## **ARCHITECTURAL REVIEW COMMITTEE MEMORANDUM**

SUBJECT: MINDY REED, OWNER, REQUESTING A LAND USE PERMIT AND A WAIVER TO CONTINUE THE USE OF AN ENLARGED PARKLET LOCATED AT 140 SOUTH PALM CANYON DRIVE, ZONE CBD, (CASE 21-096 LUP). (AP)

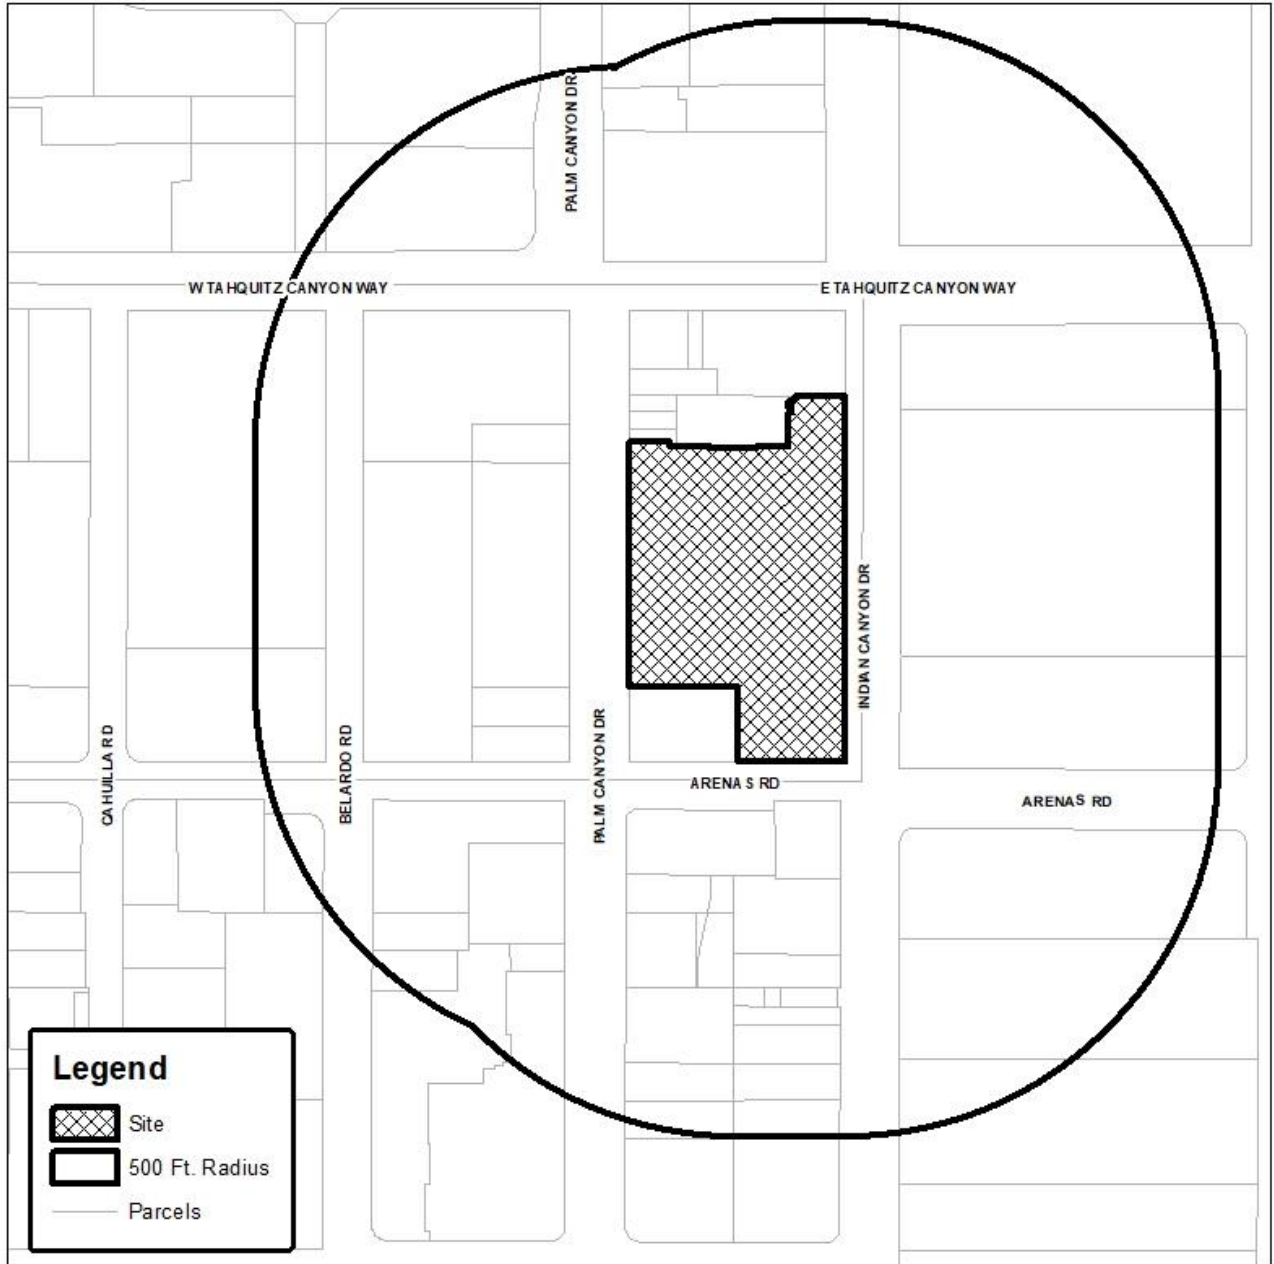
- Remove all metal planters.
- Remove K-rails, except for the safety K-rail on the north side of the parklet. Said K-rail shall be screened from the public view and installed behind parklet barrier.
- Remove all but one sign on the parklet structure.
- Reduce the width of the parklet to 8 feet, which should be measured from the face of curb to the light fixtures and the cantilever wooden structure.
